M95M01-DF package mechanical data modifications

This errata sheet applies to the M95M01-DF, which is 1 Mbit serial SPI bus EEPROMs, and specifically to the devices delivered in 8-bump wafer-level chip-scale packages (WLCSP).

Figure 2. D and E front side view

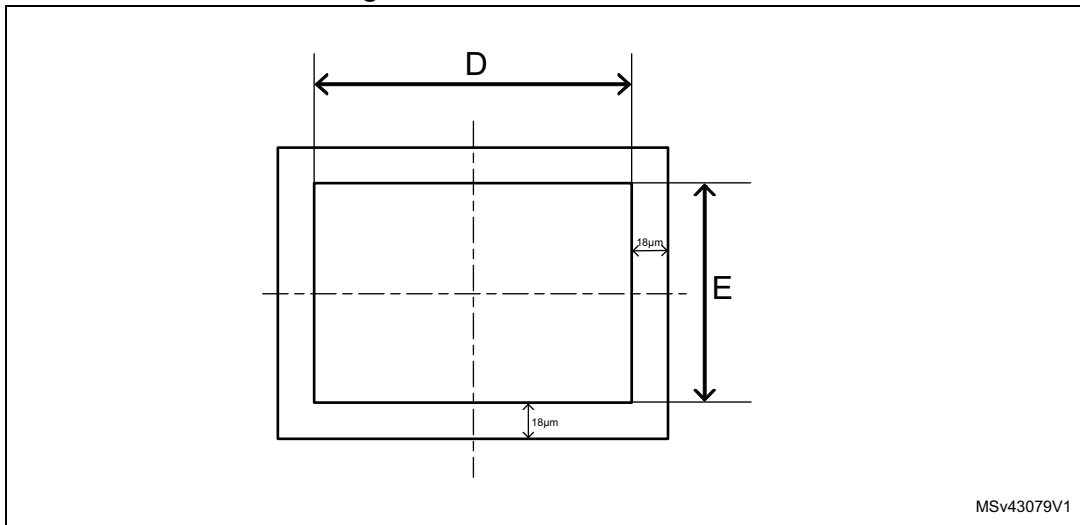
- The D and E values in the M95M01-DF datasheet correspond to front side view (ball side), instead of back side view (marking side view).
[Table 2](#) and [Table 3](#) report the data for the front and back view, respectively.

Table 2. D and E values corresponding to front side view

Symbol	Millimeters			Inches		
	Min	Typ	Max	Min	Typ	Max
D	-	2.560	2.580	-	0.1008	0.1016
E	-	1.698	1.718	-	0.0669	0.0676

Figure 3. D and E back side view

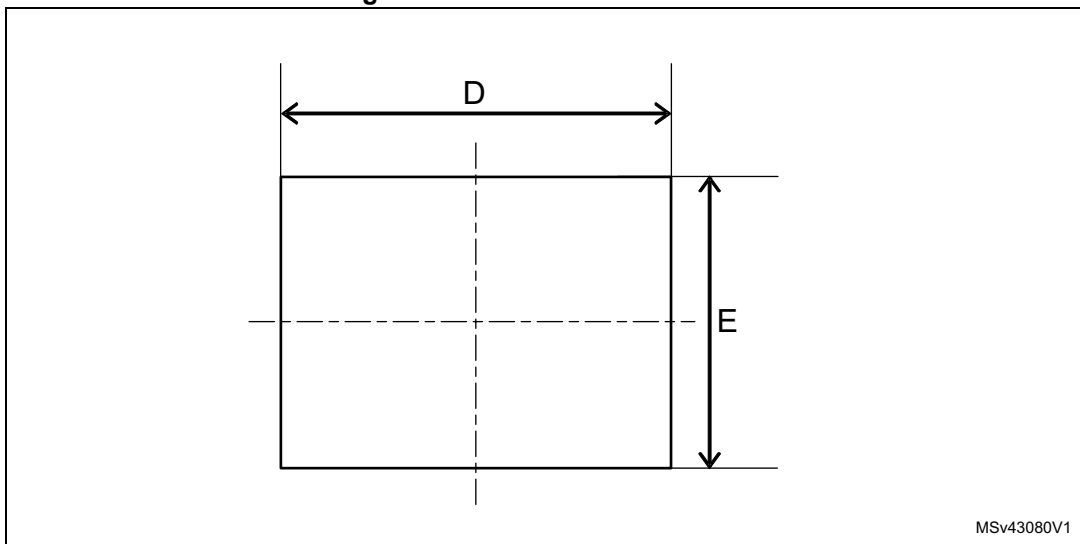
This document refers to the changes in dimensions D and E (see [Figure 3](#)) described in the M95M01-DF datasheet, in tables detailing the dimensions of the WLCSP 8-bump package.

D and E values must be modified to correct the following mistake:

Table 3. D and E values corresponding to back side view

Symbol	Millimeters			Inches		
	Min	Typ	Max	Min	Typ	Max
D	-	2.578	2.598	-	0.1015	0.1023
E	-	1.716	1.736	-	0.0676	0.0683

Figure 4. D or E side view

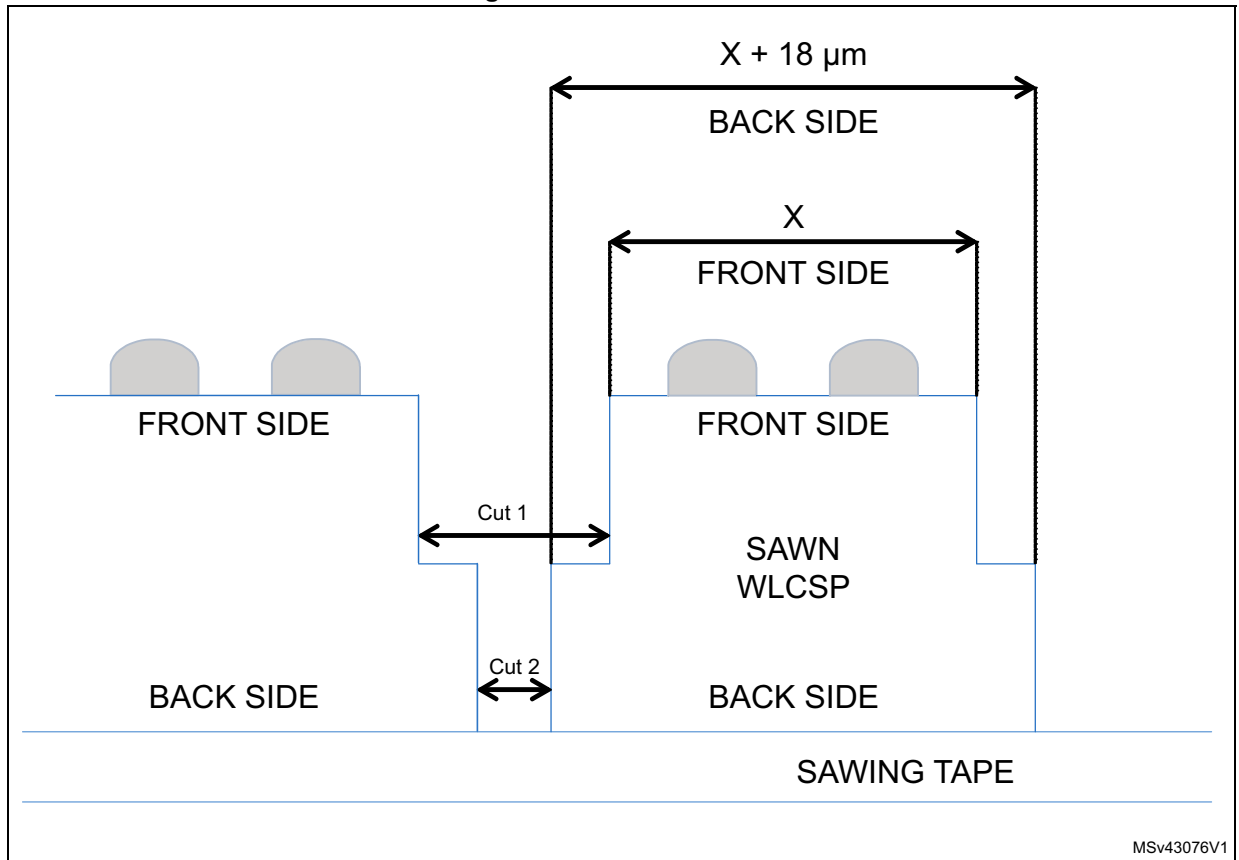
The difference between back side and front side dimension is 18 μm (0.018 mm). This difference is due to the two-step sawing process, where cut 1 and cut 2 are performed with blades having different thicknesses (see [Figure 4](#) in which X represents D or E and it has the same value and tolerance).
